DART AEROSPACE LTD		Work Order: 125683
Description: Crosstube Assembly		Part Number: D407-667-145
Inspection Dwg: D407-667-145 Rev: C		Page 1 of 2

DESIGN	CP	DART AEROSPACE LTD	
DRAWN	RF	HAWKESBURY, ONTARIO, CANADA	
CHECKED	CP	DRAWING NO. D407-667-145	REV. C
MFG. APPR.	CP	SHEET 4 OF 4	
APPROVED	CP	TITLE	SCALE
DE APPR.	CP	CROSSTUBE ASSY (407 HIGH FWD)	NTS
DATE	08.11.06	<small>COPYRIGHT © 2002 BY DART AEROSPACE LTD THIS DOCUMENT IS PRIVATE AND CONFIDENTIAL AND IS SUPPLIED ON THE EXPRESS CONDITION THAT IT IS NOT TO BE USED FOR ANY PURPOSE OR COPIED OR COMMUNICATED TO ANY OTHER PERSON WITHOUT WRITTEN PERMISSION FROM DART AEROSPACE LTD.</small>

DRAWING NO. D407-667-145	TITLE CROSSTUBE ASS'Y (407 HIGH FWD)	REV. C	DART AEROSPACE LTD ENGINEERING ORDER		D.E.O. NO. D407-667-145-C-1	SHEET NO. SHEET 1 OF 1	SCALE NTS
DRAWN 90	CHECKED ASS	MFG. APPR. 123	APPROVED WD		DE APPR. H		
DATE 11.07.15	DATE 11.07.22	DATE 11.07.22	DATE 11/07/22		DATE 11.07.21

DRAWING NO. D407-667-145	TITLE CROSSTUBE ASS'Y (407 HIGH FWD)	REV. C	DART AEROSPACE LTD ENGINEERING ORDER	D.E.O. NO. D407-667-145-C-2	SHEET NO. SHEET 1 OF 1	SCALE NTS
DRAWN AJS	CHECKED J	MFG. APPR. E	APPROVED AP	DE APPR. H	DATE 12.08.02	DATE 12.08.0

WALL THICKNESS MEASUREMENT

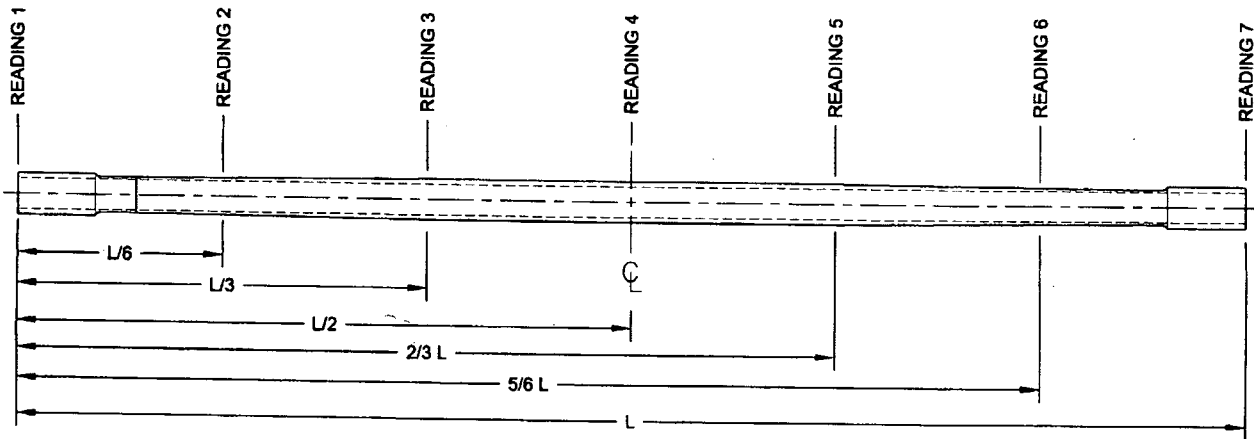
Root Cause		Date	Step	Qty	Description of work order update or non-conformance	Initial Chief Eng	Action Description	Sign & Date	Verification	QC Inspector
Design		14/10/29	100	1	Wall thickness out of tolerance. Min wall is 0.016 below nominal. RC Material	DAS 12 9-89 14/10/29	Acceptable. 06010 allows ± 0.032 eccentricity	DAS 12 9-89 14/10/29	 14-10-30	DAS 16 9-89 14/11/12
Doc/Data										
Equip/Tooling										
Handling/Pre										
Material	X									
Operator										
Offset/Setup										
Process										
Supplier										
Training										
Transport										
Unapproved

DETAIL P
BONDING STRAP INSTALLATION 2 PL

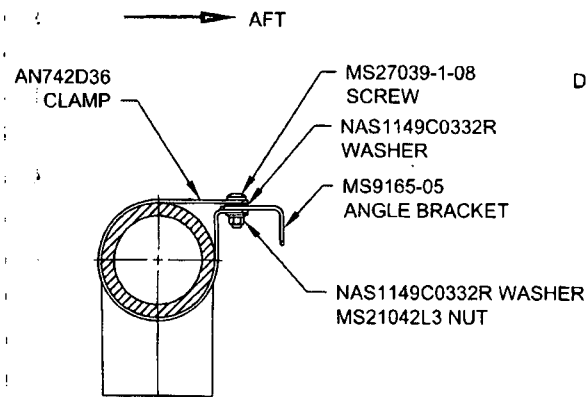
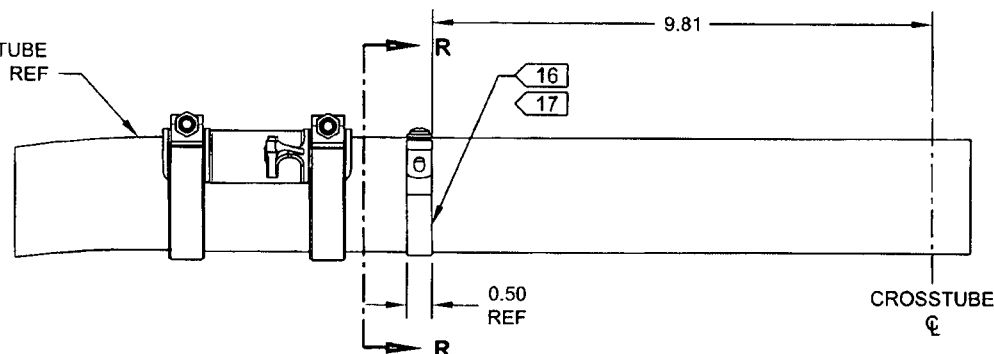
ADD ELECTRICAL GROUNDING STRAP

ITEM	QTY -145	PART NUMBER	DESCRIPTION
1	X	D407-667-145	CROSSTUBE ASSEMBLY (407 HIGH FWD)
10	2	AN742D36	CLAMP
11	2	MS9165-05	ANGLE BRACKET
12	2	MS21042L3	NUT (OR MS21042-3)
13	2	MS27039-1-08	SCREW
14	4	NAS1149C0332R	WASHER (OR AN960C10L)

- 16) MASK AREA UNDER CLAMP PRIOR TO PAINTING
- 17) SEAL EDGES WHERE AN742D36 CLAMP MEETS WITH THE CROSSTUBE USING SIKAFLEX-241/-291 OR MIL-S-8802 CLASS B2 OR PROSEAL 890 SEALANT
- 18) PERFORM RESISTANCE CHECK TO ENSURE MAX RESISTANCE IS 10 MILLIOHMS
